**AMENDMENTS TO DRAWINGS**

**REMARKS**

Application No.: 10/814,639

Docket No.: A8319.0007/P007-A

FIG. 19

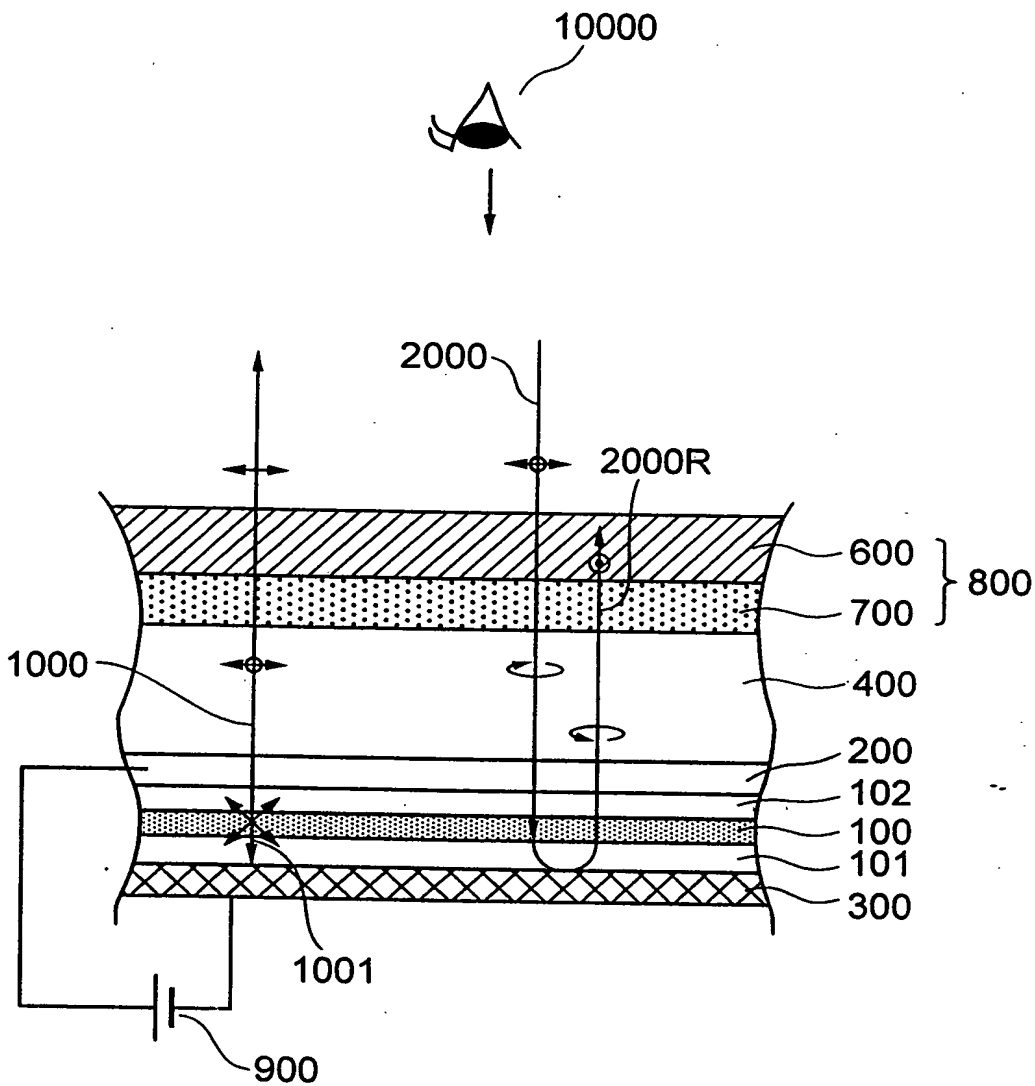
Figure 19 is objected to as being informal. The Examiner requests that the drawing be labeled as prior art. The drawing has been changed, as required.
